EXAMINATION, TESTING, AND EVALUATION OF  
IRRADIATED PRESSURE VESSEL SURVEILLANCE  
SPECIMENS FROM THE MONTICELLO  
NUCLEAR GENERATING PLANT

NORTHERN STATES POWER COMPANY

November 5, 1984

LIST OF CHANGES FOR BCL-585-84-2 REVISION 1

FIGURE 24. BASE METAL YIELD AND ULTIMATE TENSILE STRENGTHS VERSUS TEST TEMPERATURE FOR THE IRRADIATED TENSILE SPECIMENS FROM THE MONTICELLO 30 DEGREE SURVEILLANCE CAPSULE

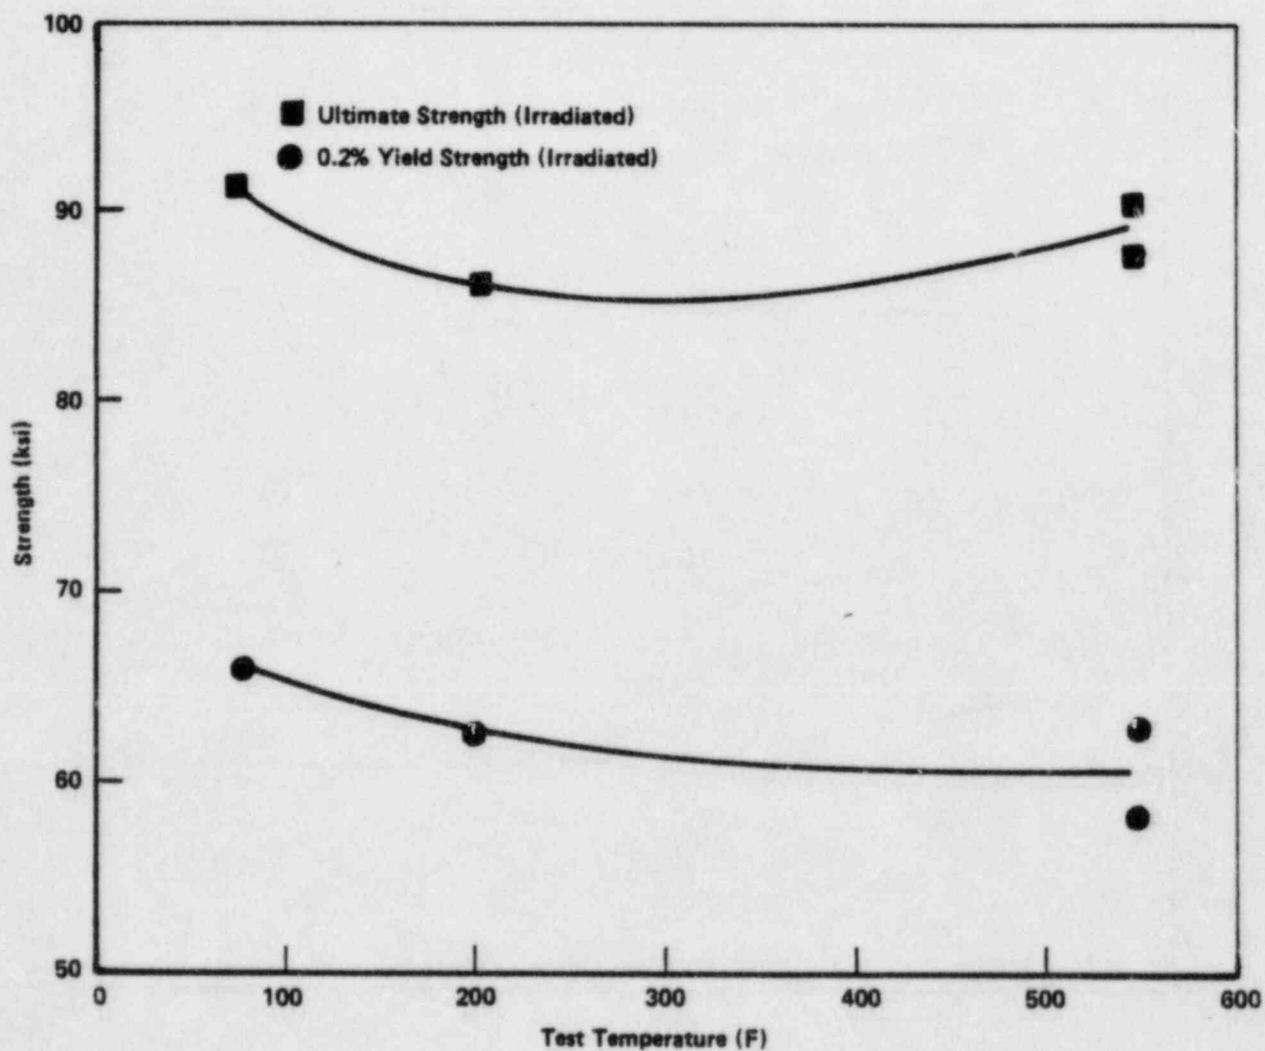
| <u>Page</u> | <u>Line</u>                      | <u>Changes</u>   |
|-------------|----------------------------------|--|
| 64          | Figure 24                        | Plot corrected to reflect <u>TABLE 11</u> corrections  |

FIGURE 25. BASE METAL TOTAL ELONGATION AND REDUCTION IN AREA VERSUS TEST TEMPERATURE FOR THE IRRADIATED TENSILE SPECIMENS FROM THE MONTICELLO 30 DEGREE SURVEILLANCE CAPSULE

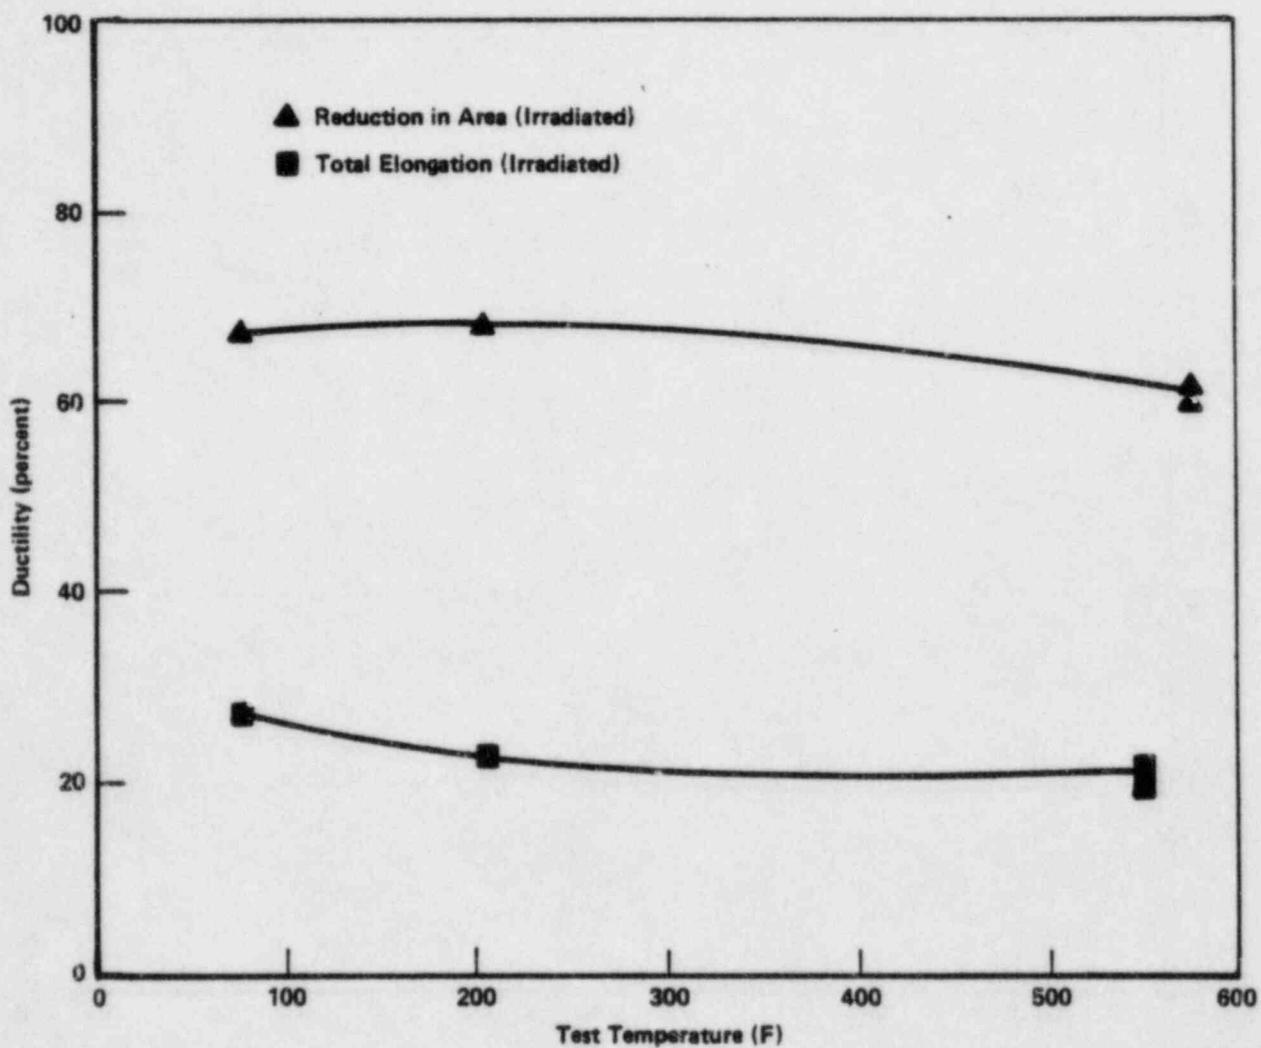
| <u>Page</u> | <u>Line</u>                      | <u>Changes</u>   |
|-------------|----------------------------------|--|
| 65          | Figure 25                        | Plot corrected to reflect <u>TABLE 11</u> corrections  |

FIGURE 26. POSTTEST PHOTOGRAPHS OF THE IRRADIATED BASE METAL TENSILE SPECIMENS SHOWING BOTH THE REDUCED AREAS AND FRACTURE SURFACES (MONTICELLO 30 DEGREE SURVEILLANCE CAPSULE)

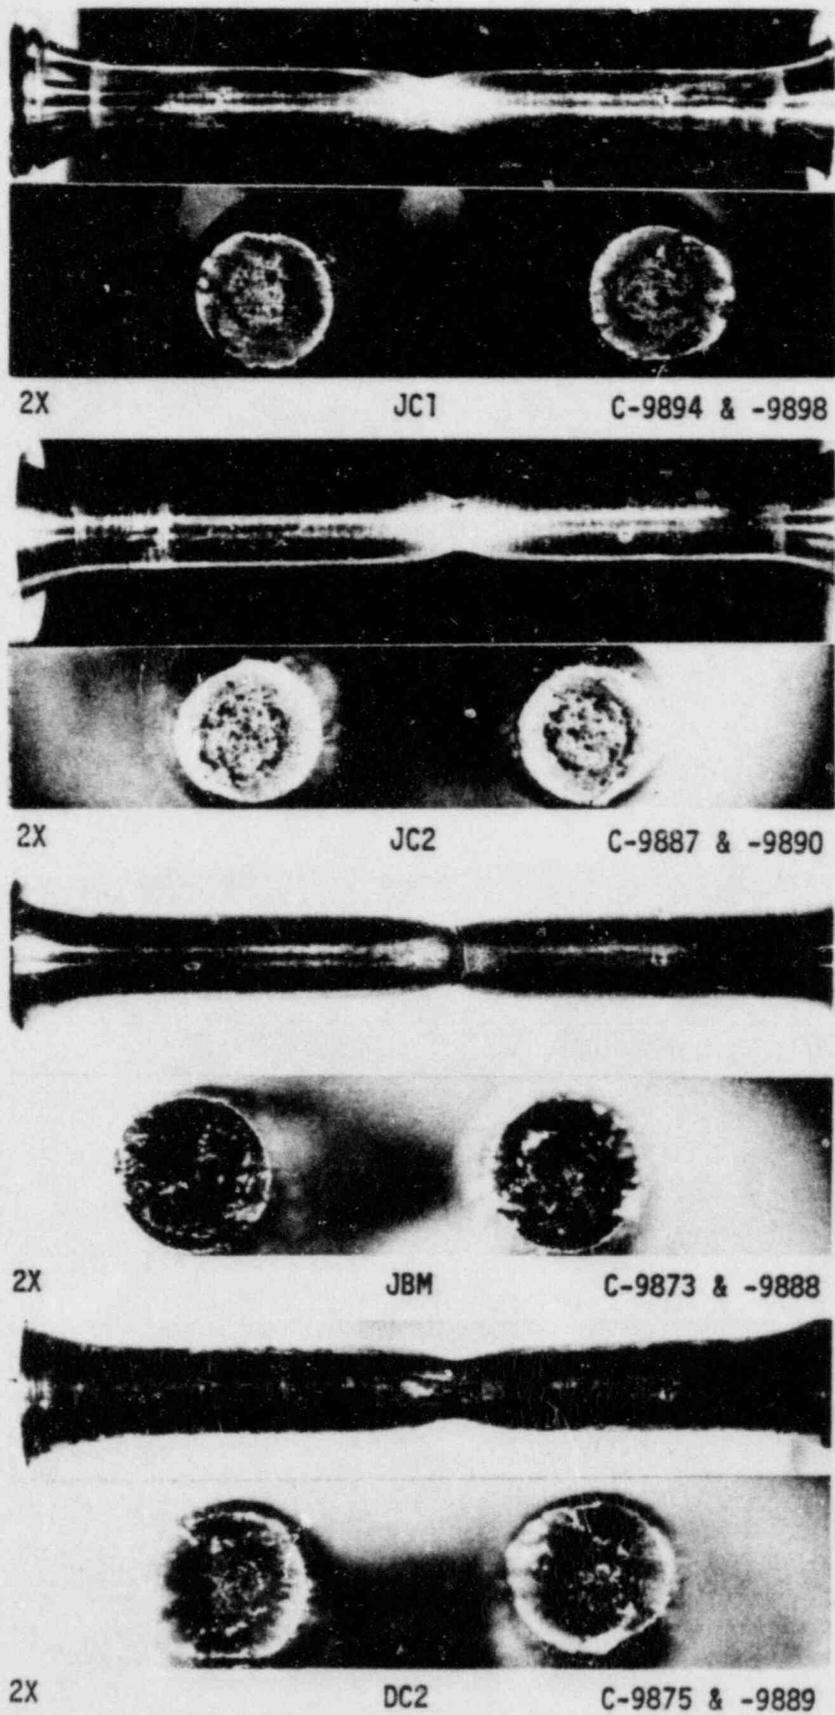
| <u>Page</u> | <u>Line</u>                      | <u>Changes</u>   |
|-------------|----------------------------------|--|
| 66          | Figure 26                        | Photos corrected to reflect tensile specimen corrections   |

FIGURE 27. POSTTEST PHOTOGRAPHS OF THE IRRADIATED WELD METAL TENSILE SPECIMENS SHOWING BOTH THE REDUCED AREAS AND FRACTURE SURFACES (MONTICELLO 30 DEGREE SURVEILLANCE CAPSULE)

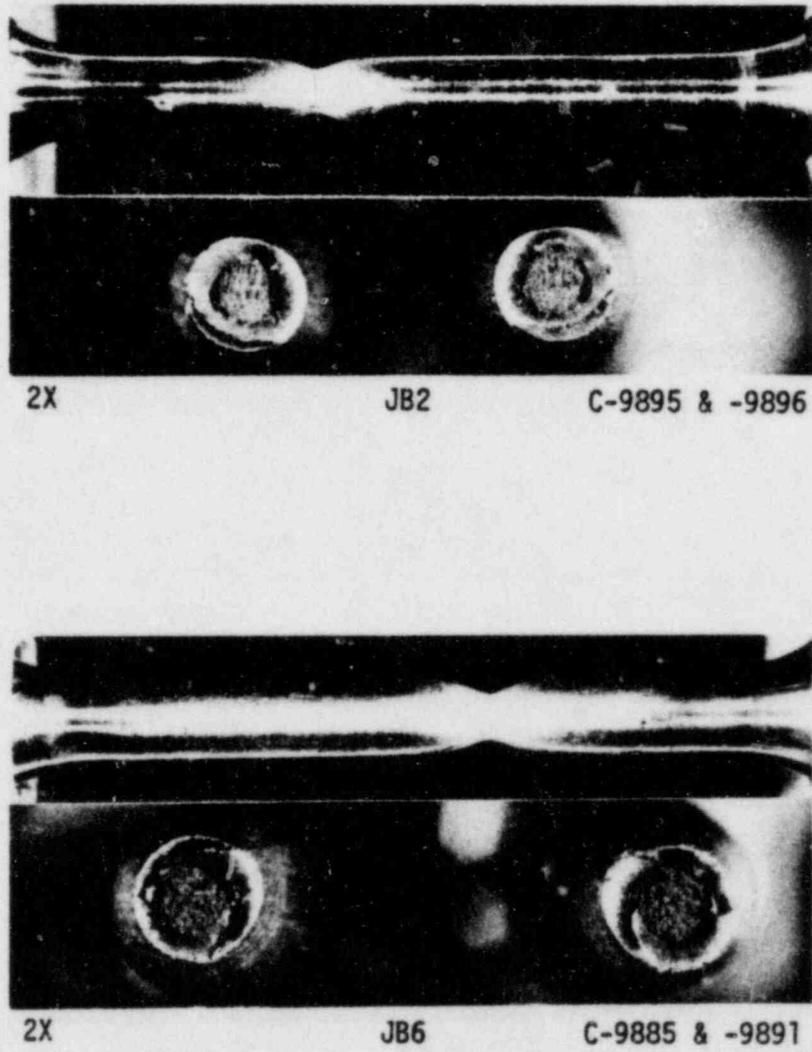
| <u>Page</u> | <u>Line</u>                      | <u>Changes</u>   |
|-------------|----------------------------------|--|
| 67          | Figure 27                        | Photos corrected to reflect tensile specimen corrections   |
